ADDENDUM NO. 2

Colton MS Pavilion Building Addition

Colton Joint Unified School District
1212 Valencia Drive
Colton, CA 92324

DSA #04-123039

FLOOR PLAN	SCALE: 1/8" = 1'-0"	1
------------	------------------------	---

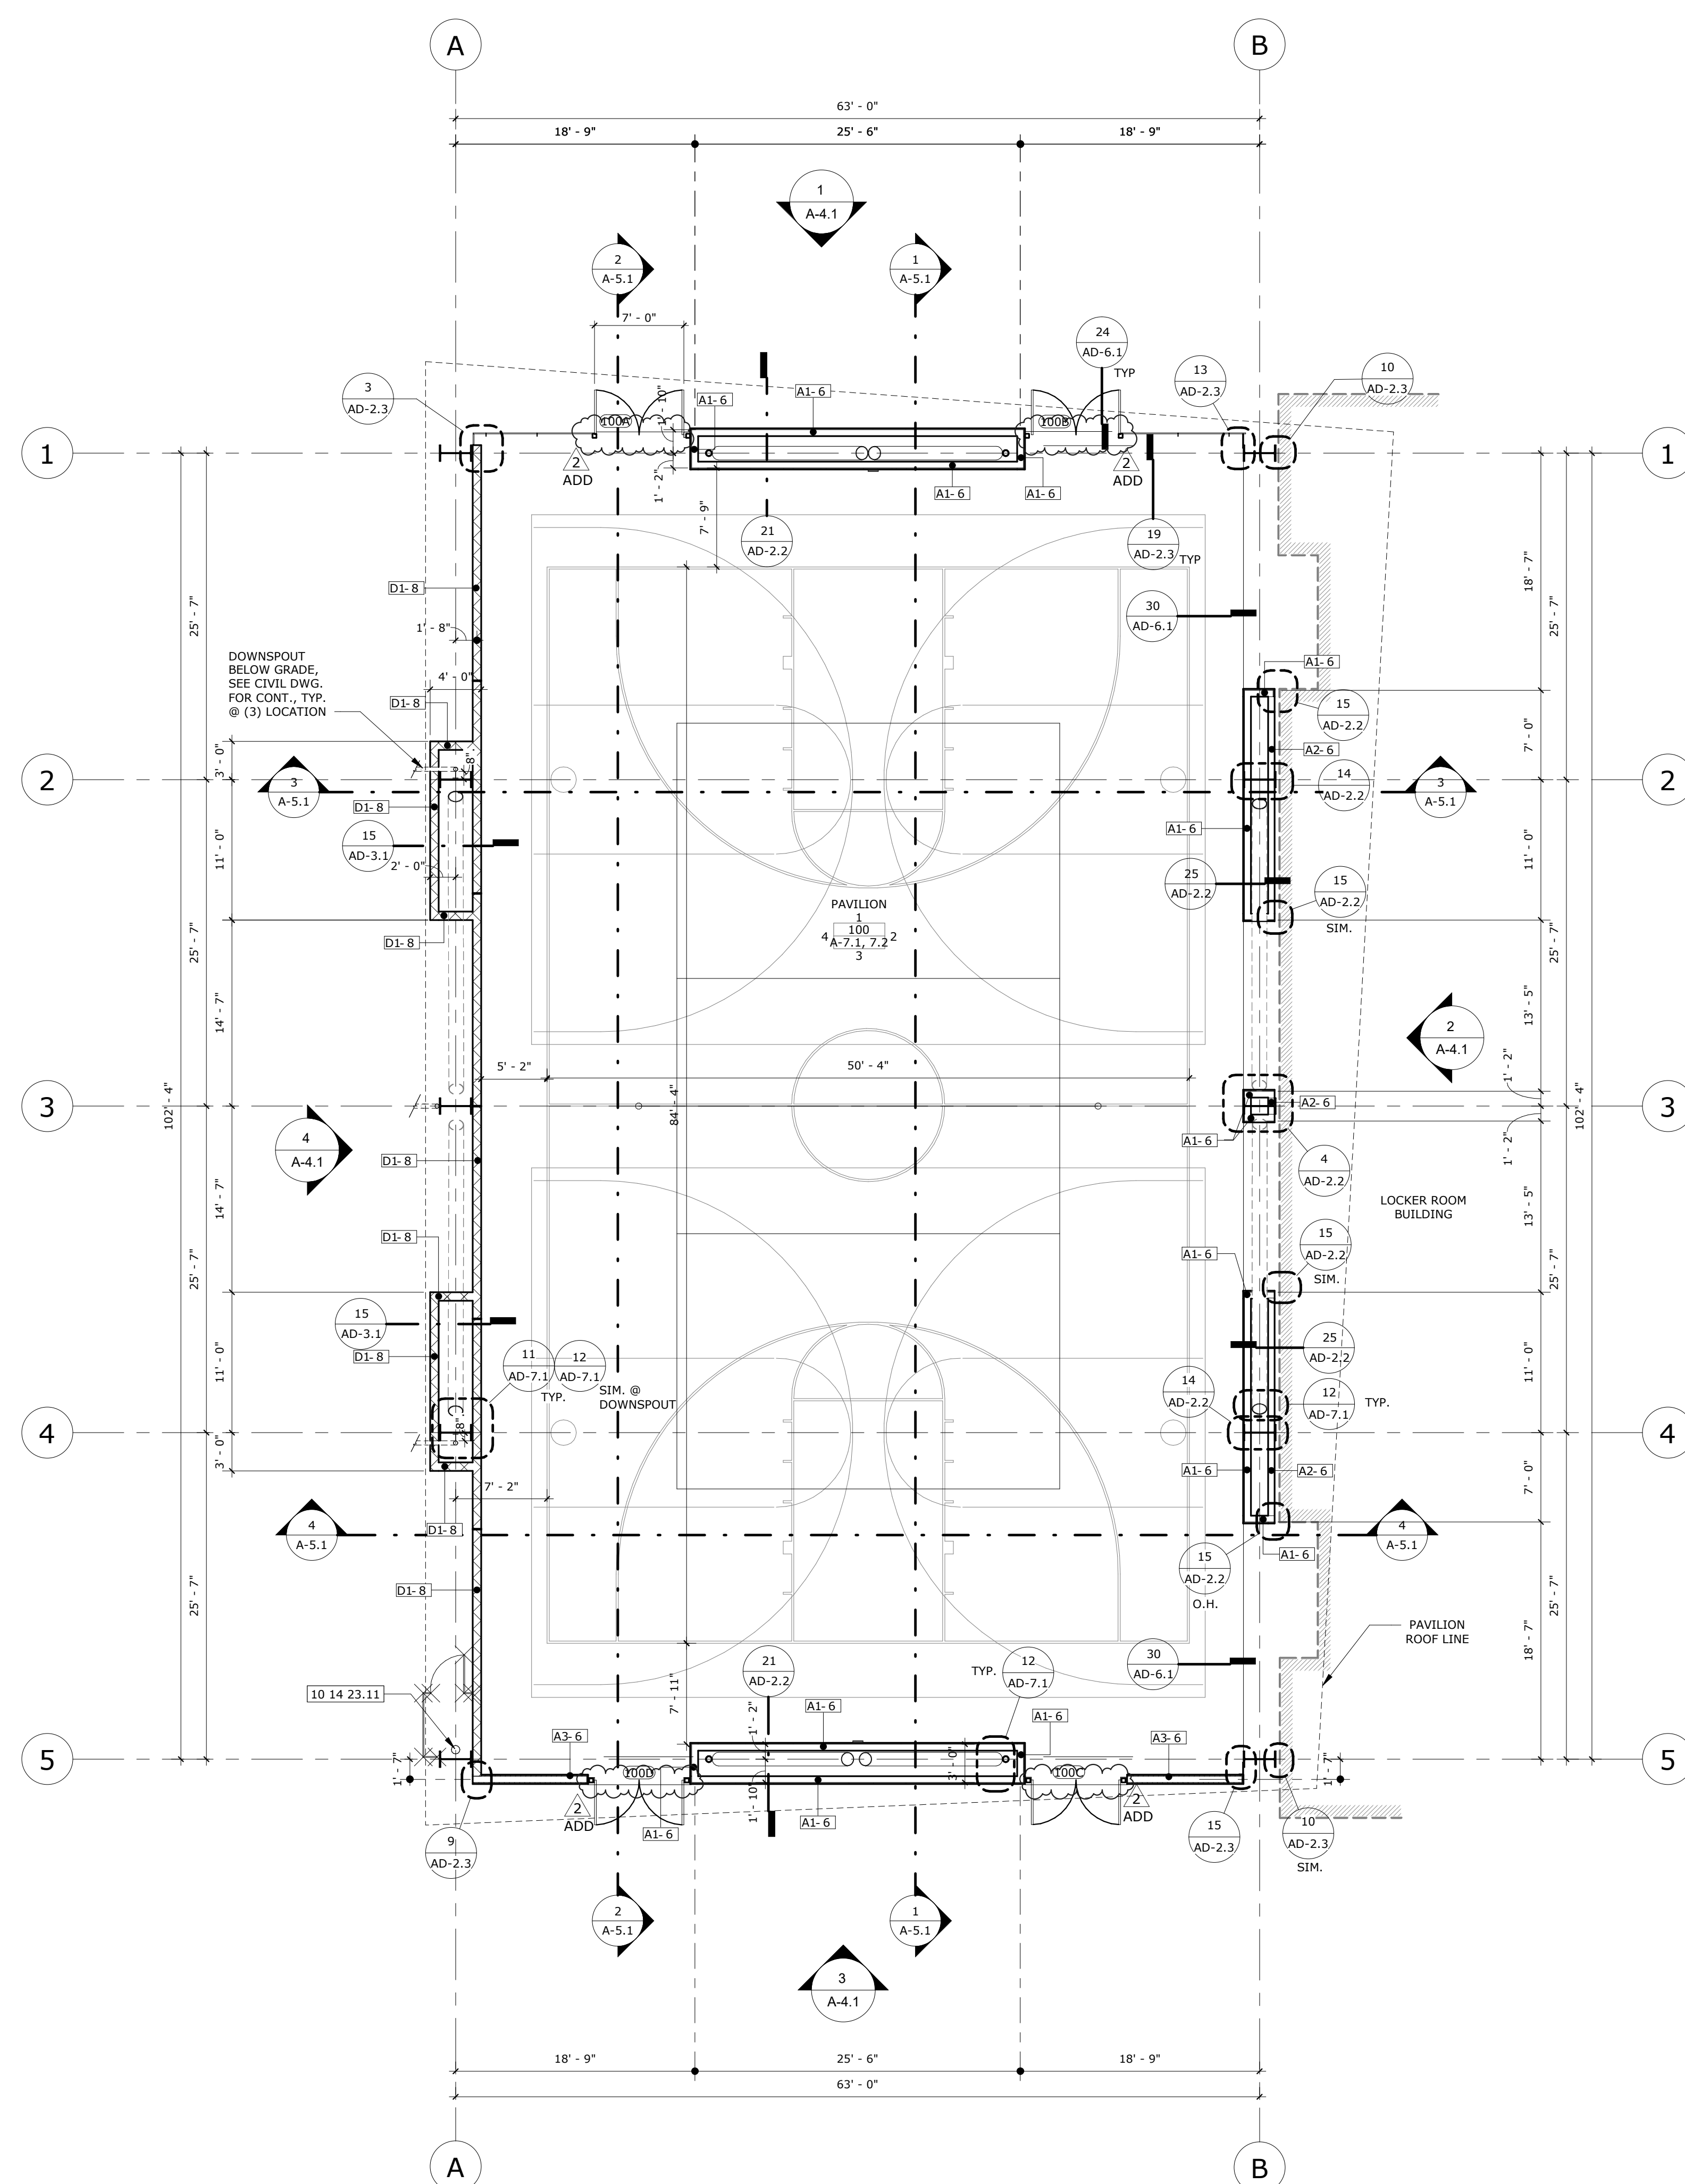
| 2.5.1 | Revised Keynotes and Floor Plan per clouded areas. |
